Submission Objecting to State Significant Development (SSD-78493518)

2-8 Highgate Road, Lindfield NSW 2070

Figure 1: 400m distance

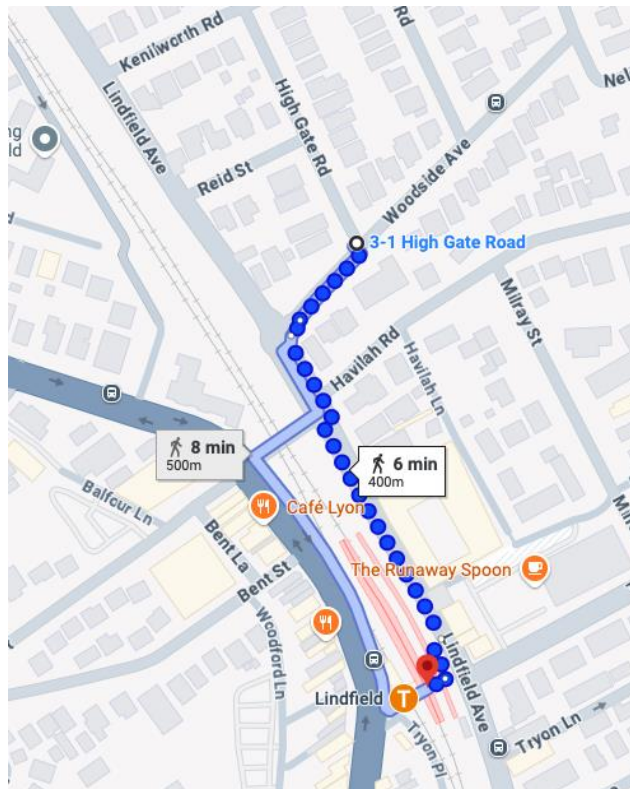
- **TOD Boundary Discrepancy:**
 - The site's inclusion wholly in the TOD area is questionable.
 - Measuring 400m *walking distance* from Lindfield Station's ticket office, only the southeast corner (Woodside/Highgate intersection) OR midpoint of Lindfield Ave boundary (the limit of 2 Woodside Ave block) qualifies. (see Figures 1 & 2 below)

- Under these measurements, Blocks 4–8 Highgate Road and 1–3 Reid Street lie outside the TOD boundary and should not fall under TOD planning.
